Addendum No. 4

Diablo Road Trail and Drainage Improvement Project Project No. C-055

2010 CROW CANYON PLACE
SUITE 250
SAN RAMON, CALIFORNIA 94583-4634
(925) 866-9000
(888) 279-2698

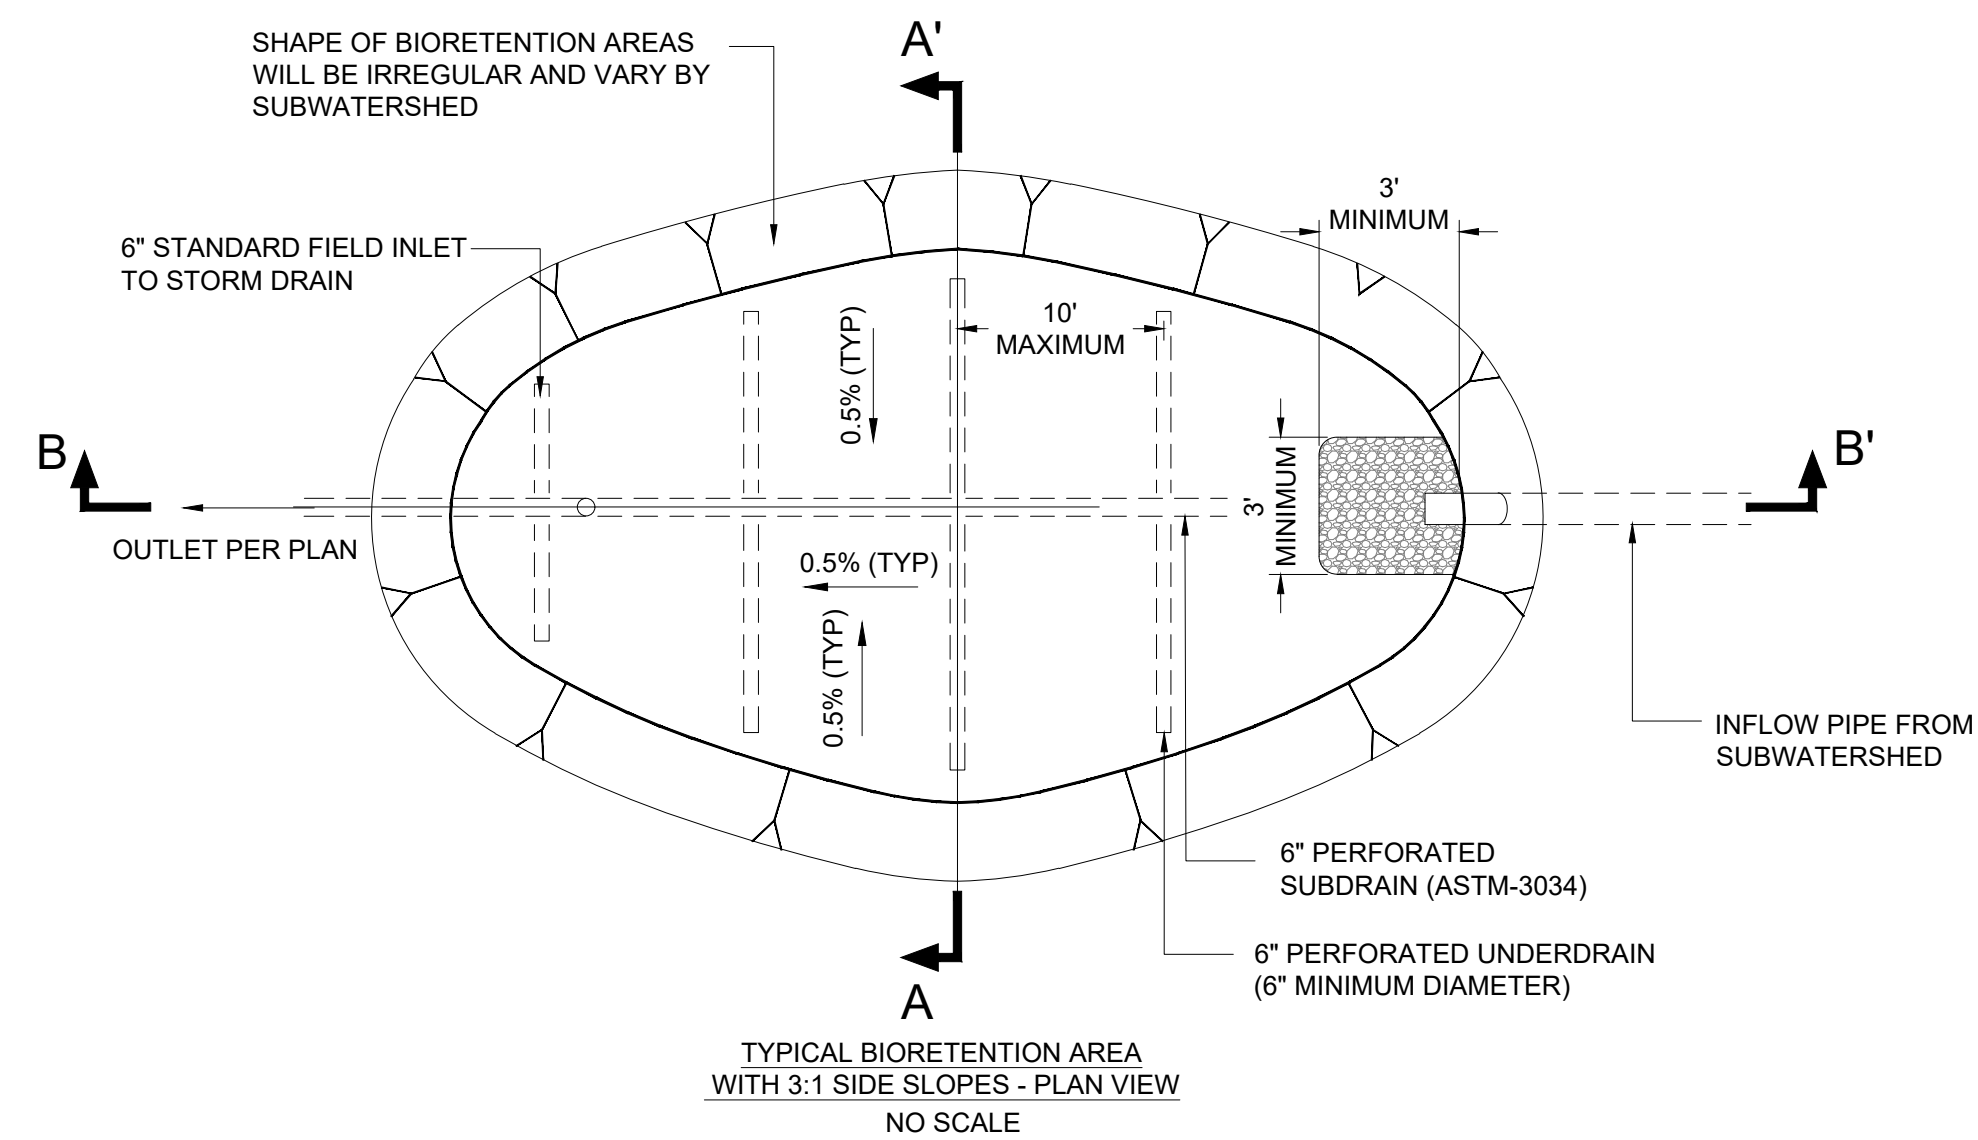
69- Soldier Pile Wall #2 (Plan Sheet 17) calls for W18x186 steel beams. These beams do not exist. Please confirm which steel beams are to be used in lieu of the W18x186 beams.

94-Profiles Shown on Sheet 17 show the Profiles for Soldier Pile Walls #1 - #3. All of them show the top of wall Precast Concrete Lagging matching the contour of the new path. Cutting the concrete lagging to match would be an arduous task. Could the City please consider a different design option for the top of Soldier Pile wall(s)?

- a. We have modified the top lagging section to reflect a timber lagging in Addendum 1.

SHEET NUMBER
18
OF 22 SHEETS
PROJECT NO.
8870.000.011

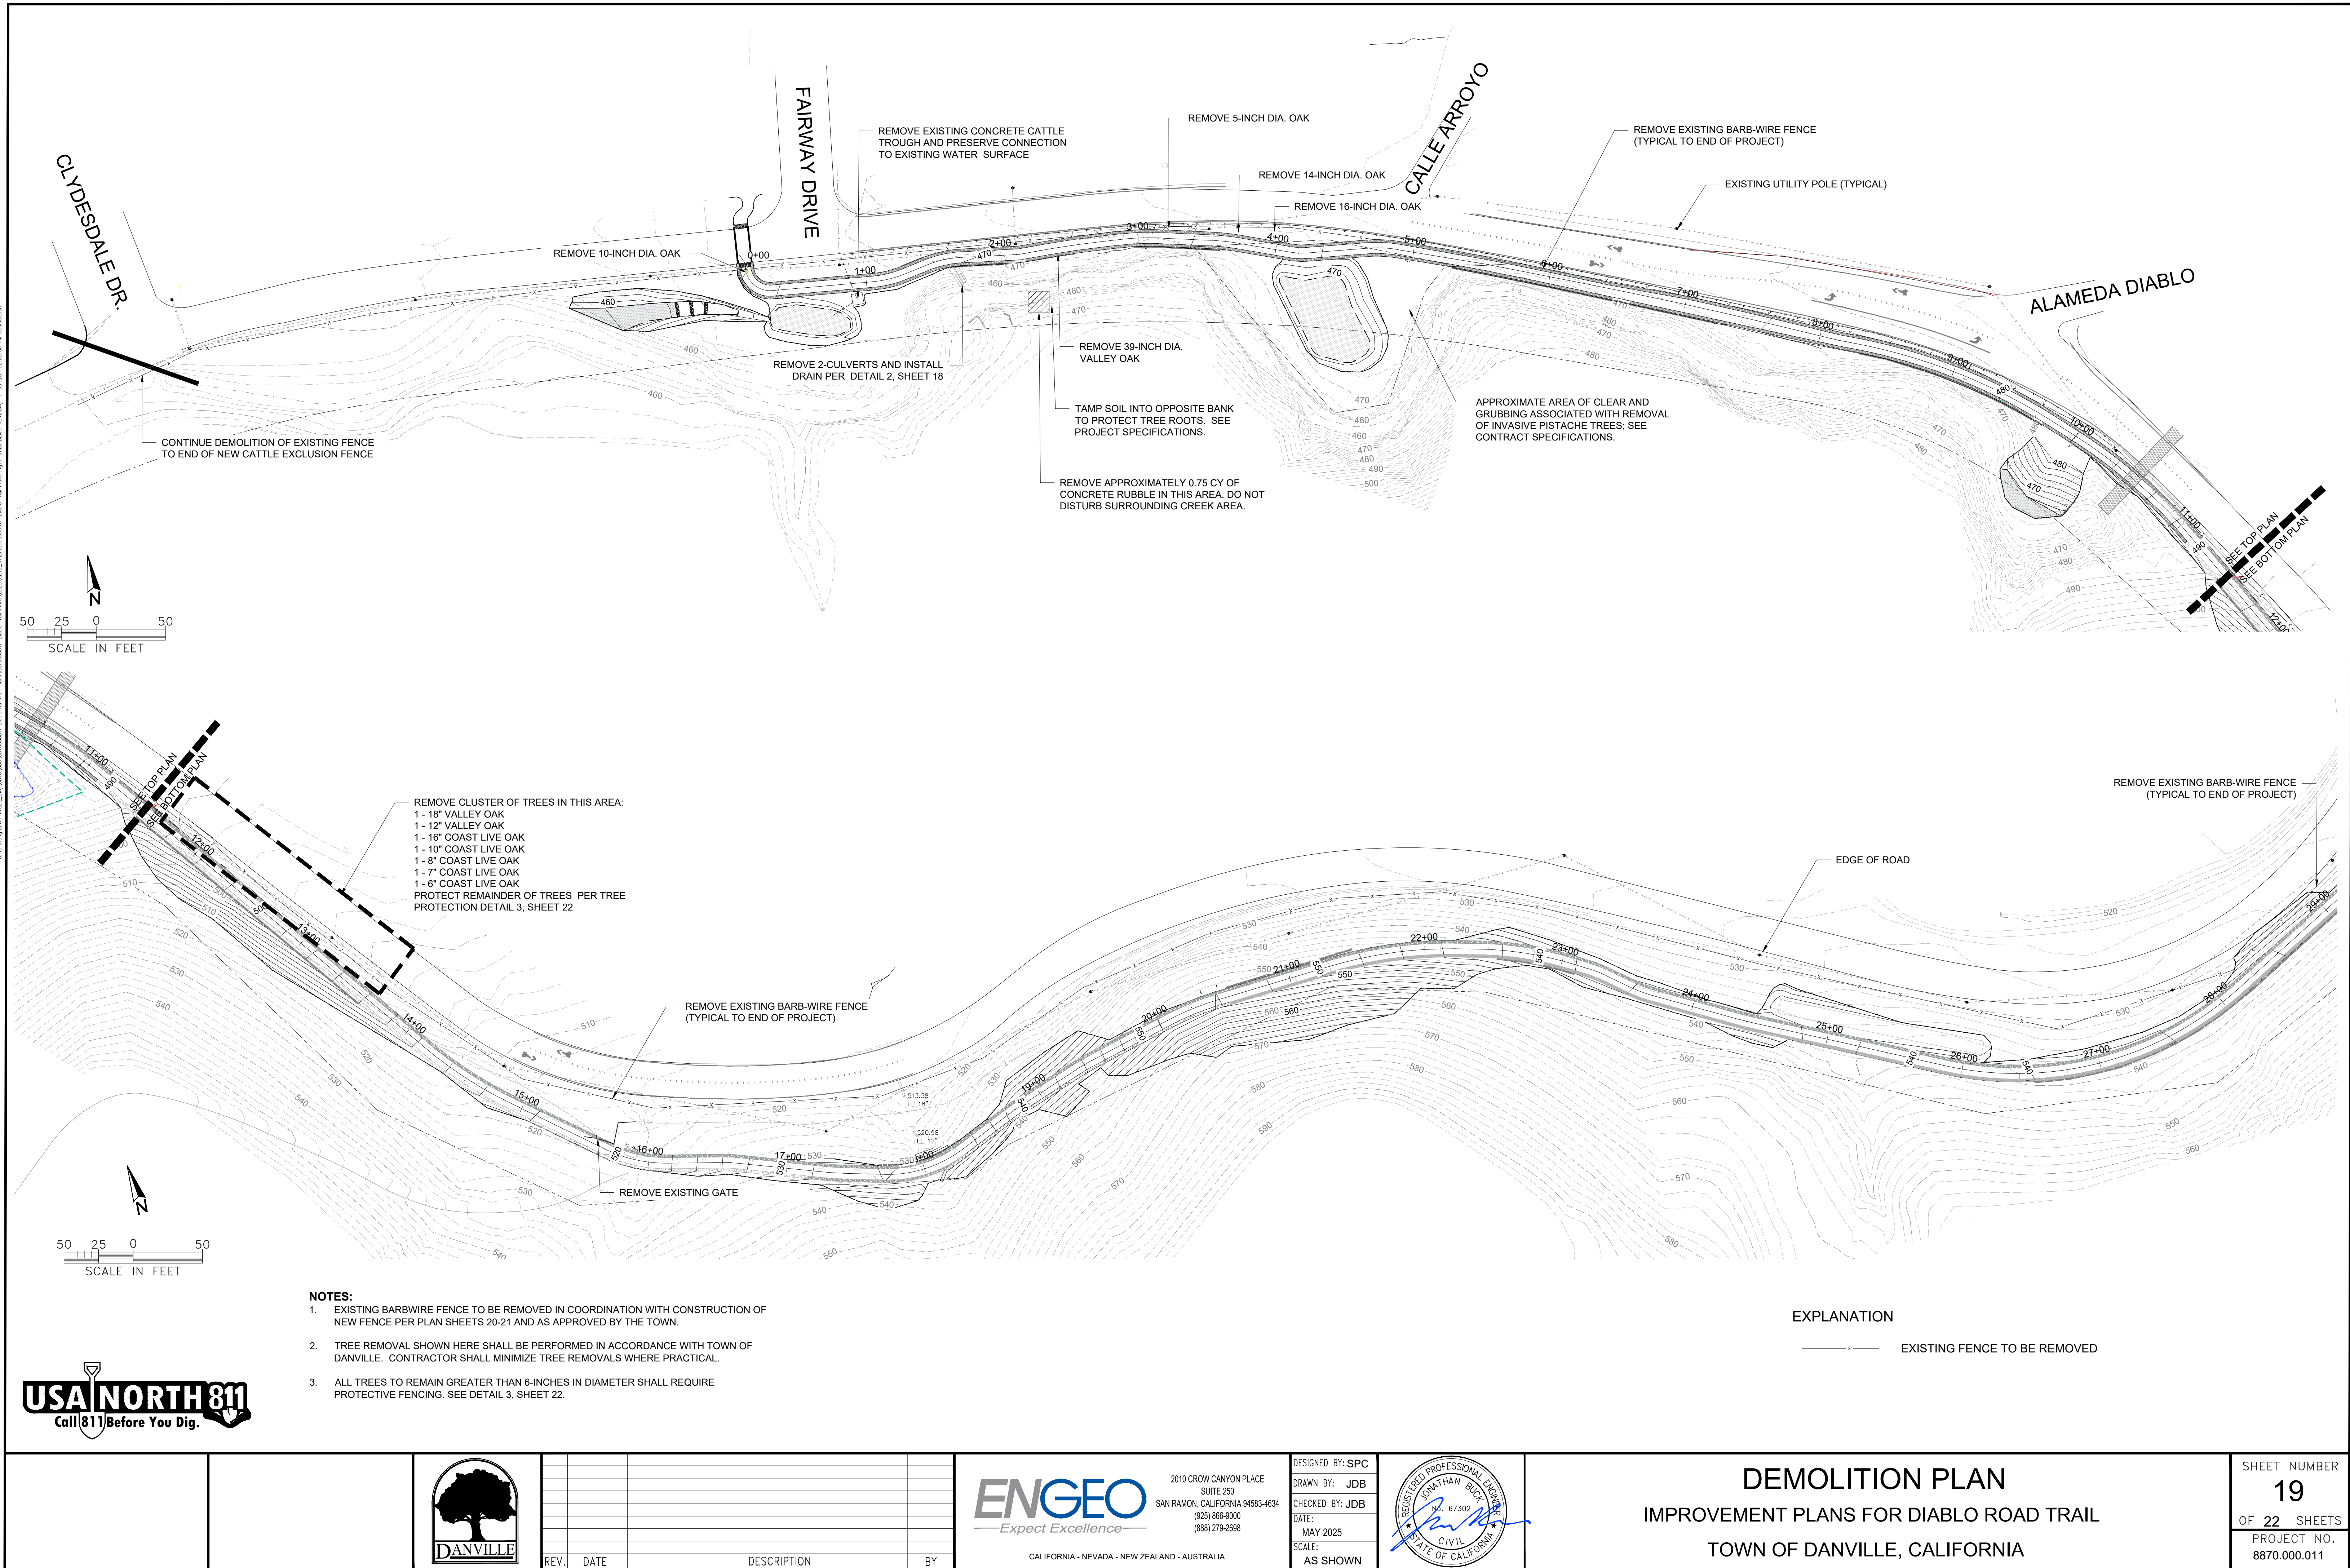
57- Please confirm you want 200 lb rock rip-rap in the 3.0' X 3.0' outfall aprons. See detail 4 on plan sheet 18.

98- Please confirm you want 200 lb rock rip-rap in the 3.0' X 3.0' outfall aprons. See detail 4 on plan sheet 18.

- a. See response to question 57.

SHEET NUMBER
19
OF 22 SHEETS
PROJECT NO.
8870.000.011

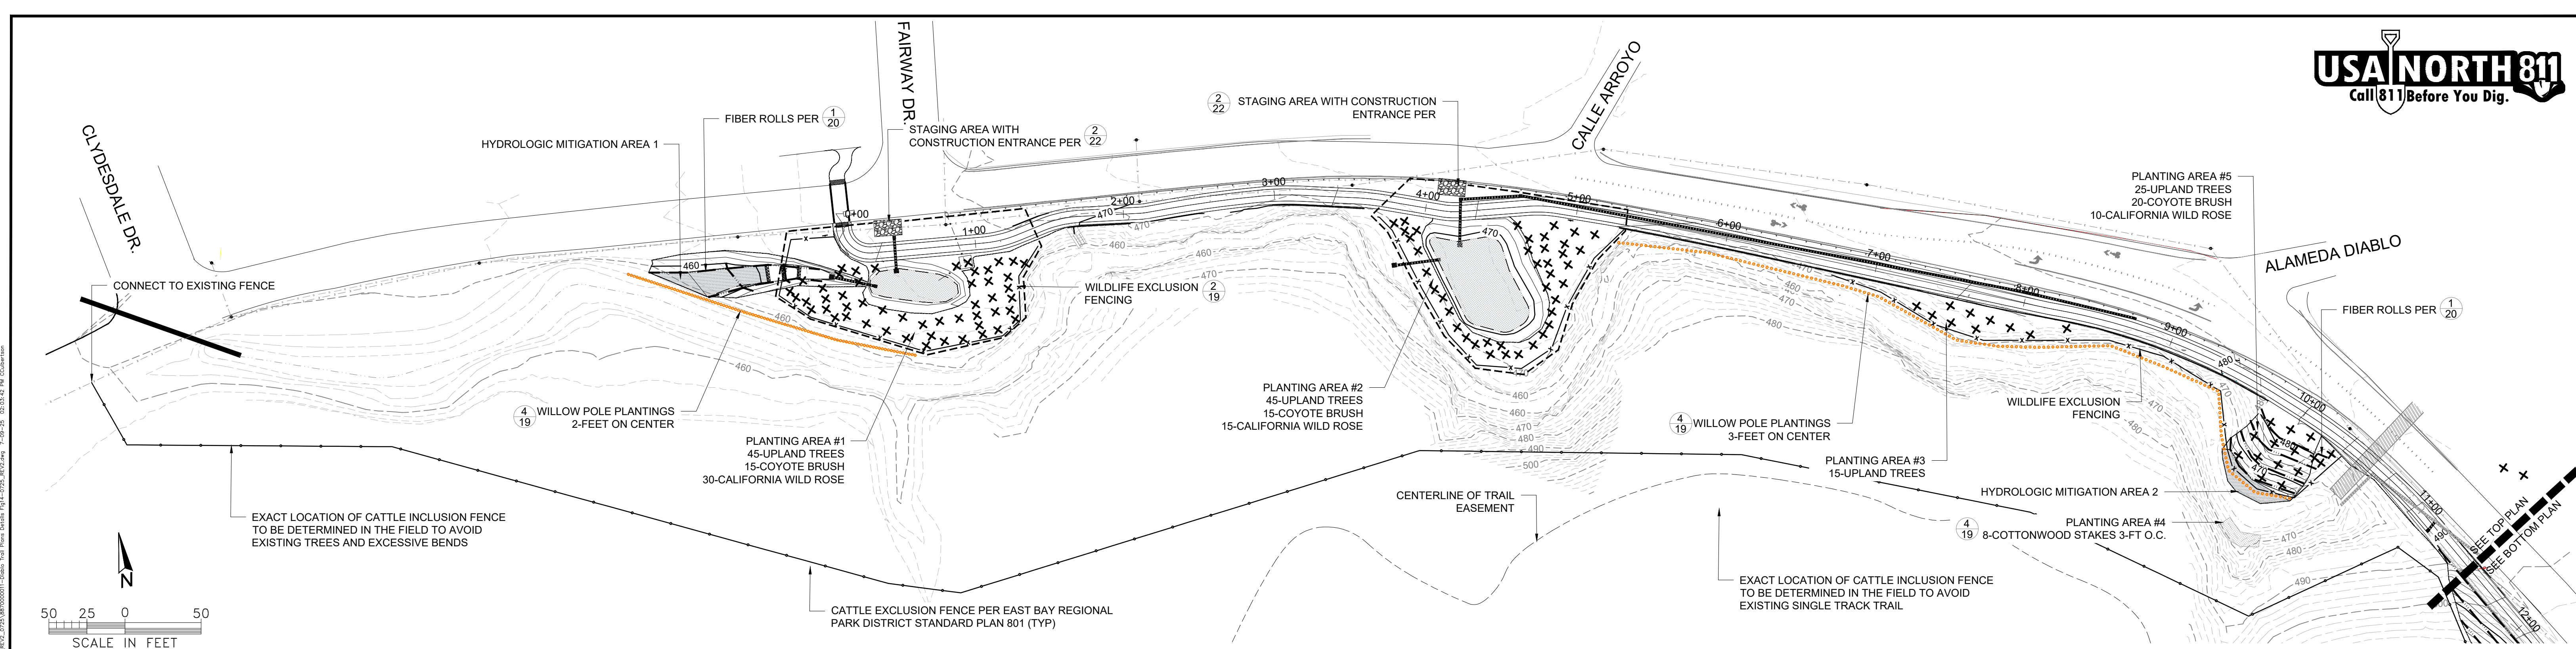
Looking at the plans there is only one tree marked (yellow dot with a black X) for removal at station 2+75 on plan sheet 3 and there are 7 trees shown on plan sheet 19. There appears to

several other trees that need removal but are not indicated on the plans. Please provide a plan that indicates which trees and the size that need to be removed. Are the trees to be removed marked in the field?

- a. See response to item 48. Tree removals are specifically called out on Sheets 19 and 20 in Addendum 1 and other symbols have been removed from these sheets. The majority of trees have been marked in the field.
